STAFF RECOMMENDATION

1110 Montrose Avenue

Application: Demolition; New Construction-Infill

Description of Project: The application is for the demolition of a non-contributing duplex and the construction of a new infill duplex.

Figure 8: Setback map

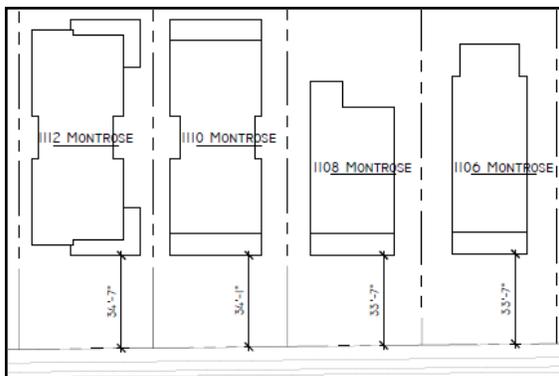
The front setback is about thirty-four feet, one inch (34'1"), which is consistent with the historic house next door, at 1108 Montrose Avenue. It appears to be about six inches (6") off, due to the gently angled front lot lines. The intent is to align the front setback with that of #1108 next door. Staff will verify the appropriate setback in the field at staking.

On the left side, the house will be six feet (6') from the side property line, on the right side, it will be ten feet (10') to accommodate the driveway. The rear of the house will be about thirty-seven feet, eleven inches (37'11") from the rear property line. These setbacks all meet the base zoning requirements.

With Staff review and approval of the front setback in the field, the project meets section III.C for setback and rhythm of spacing for new construction.

1 1112+1110 MONTROSE CONTEXTUAL SITE PLAN

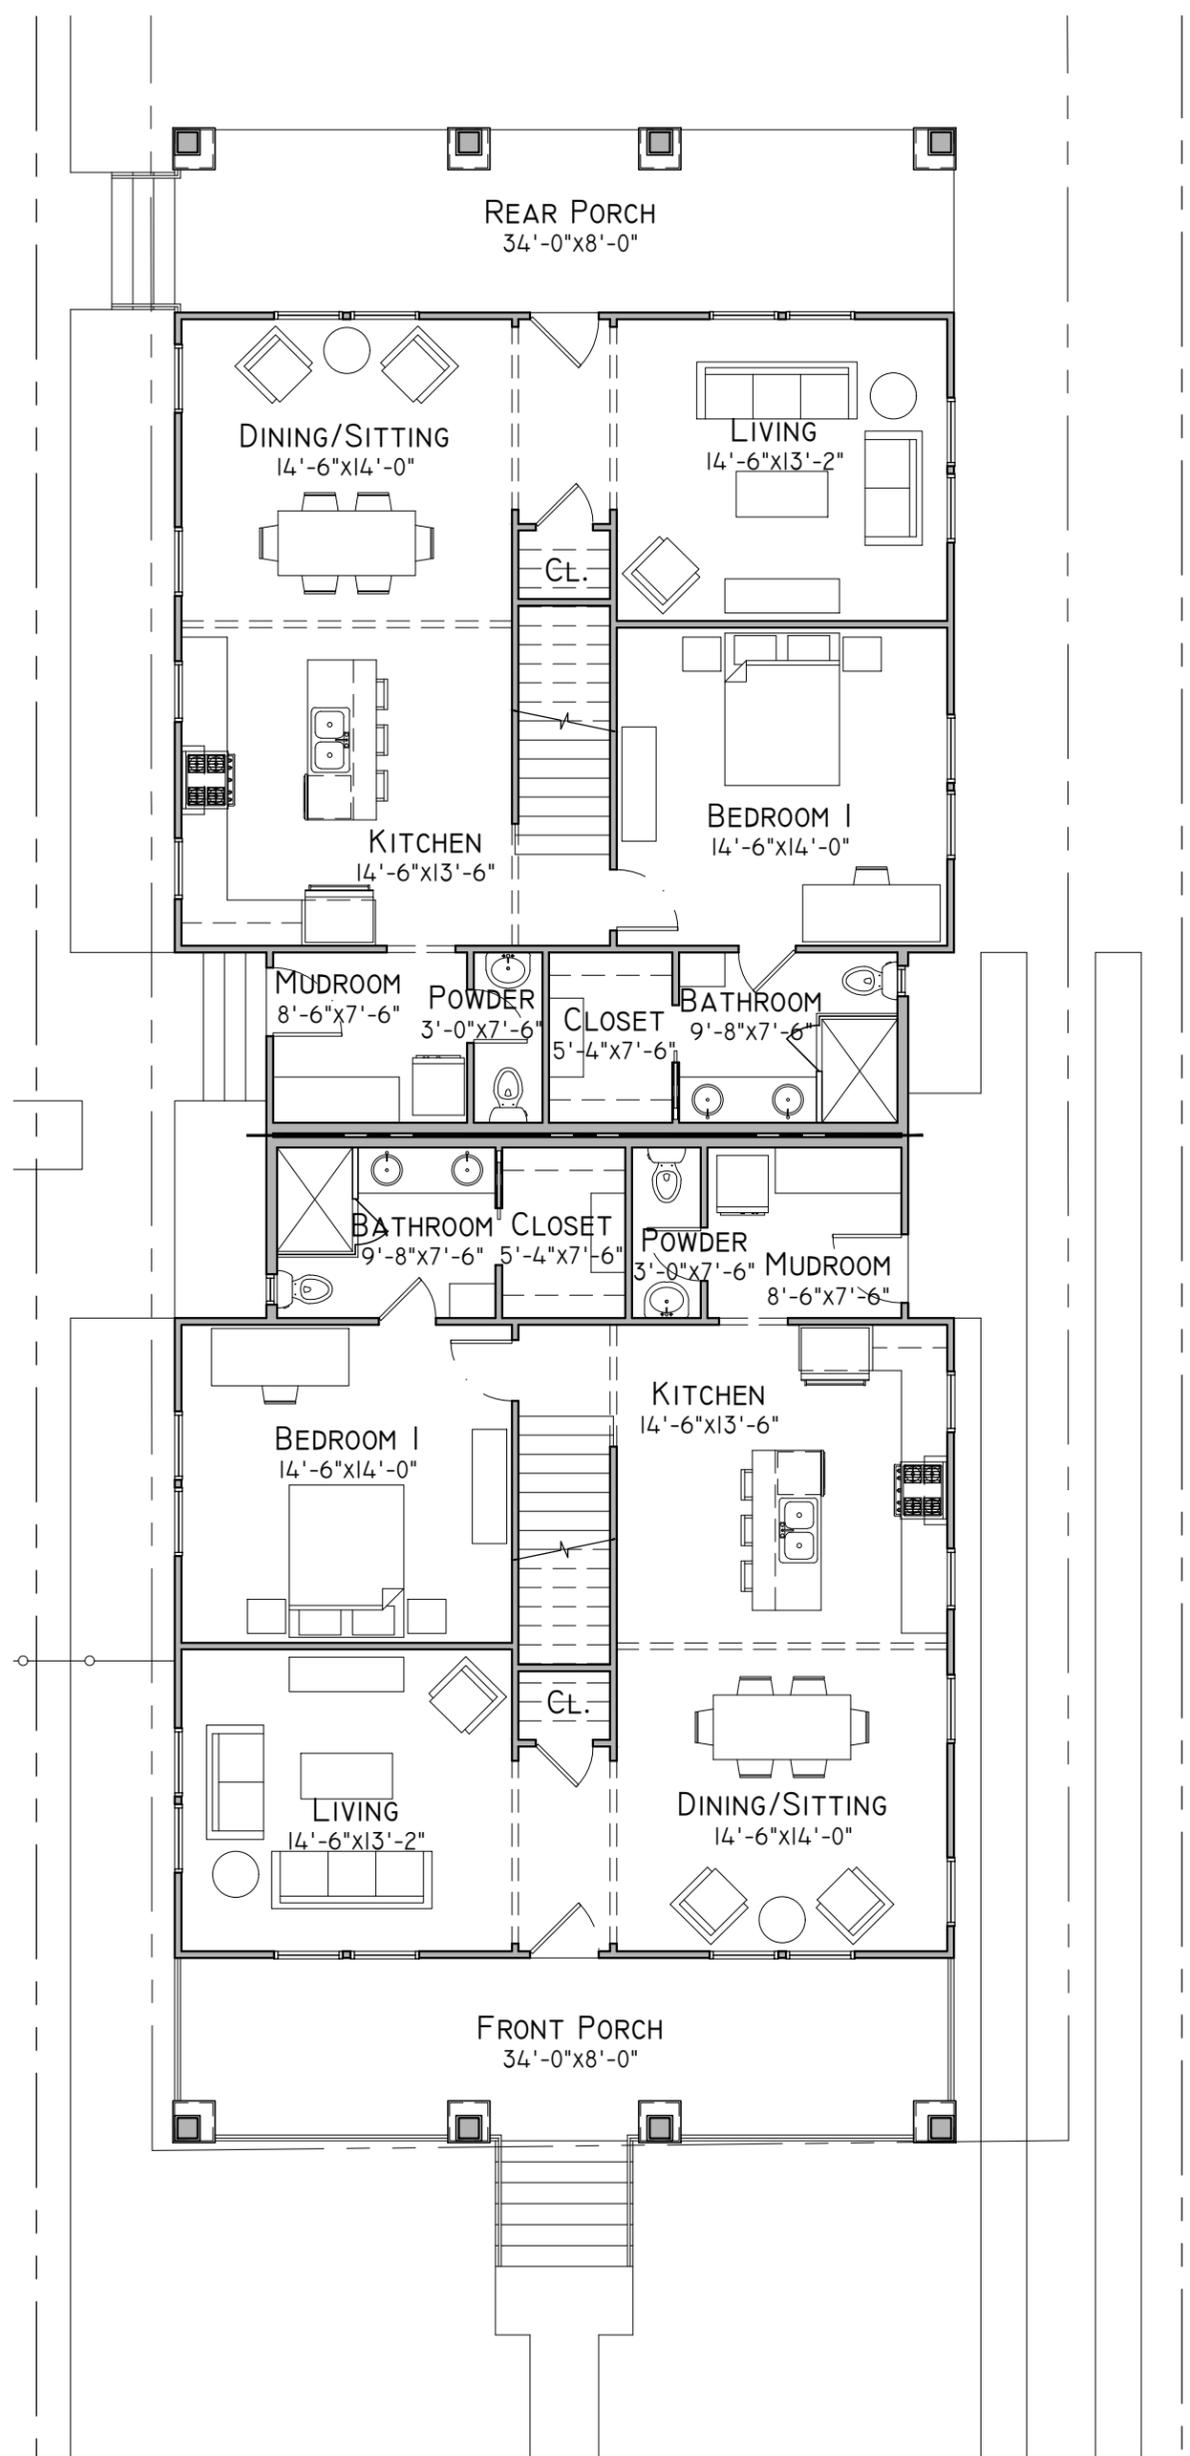
Orientation: The proposed infill faces Montrose Avenue with a full width front porch that is eight feet (8') deep. There is a walkway from the front porch to the existing sidewalk on Montrose. This is compatible with the historic context. The second unit is accessed via an additional walkway to the left of 1110 Montrose that runs from a side door to the Montrose Avenue sidewalk. The second unit has a porch which faces the alley and additional parking. To the right of the house there is an existing curb cut where a new driveway is proposed.
